Date: **June 1, 1992**

Subject: **VERTICAL SEAM IN CENTER OF DISPLAY**

Model: **PVM-1942Q/1944Q**

Figure 1

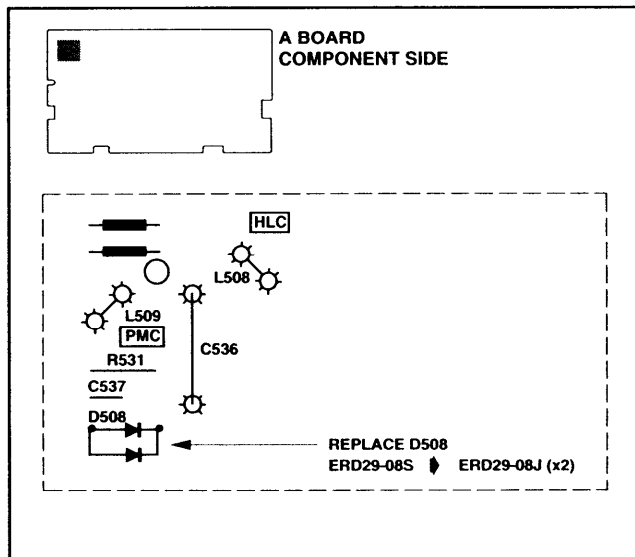
A vertical seam may sometimes appear in the center of the screen when an all-white pattern is displayed. To correct this, modify the A board as described below.

1. Remove D508 (zone B-1). If there is an ERD28-08S diode mounted in parallel to D508 on the solder side of the board, remove it also.
2. Solder two ERD29-08J diodes in parallel, and mount them in place of D508.
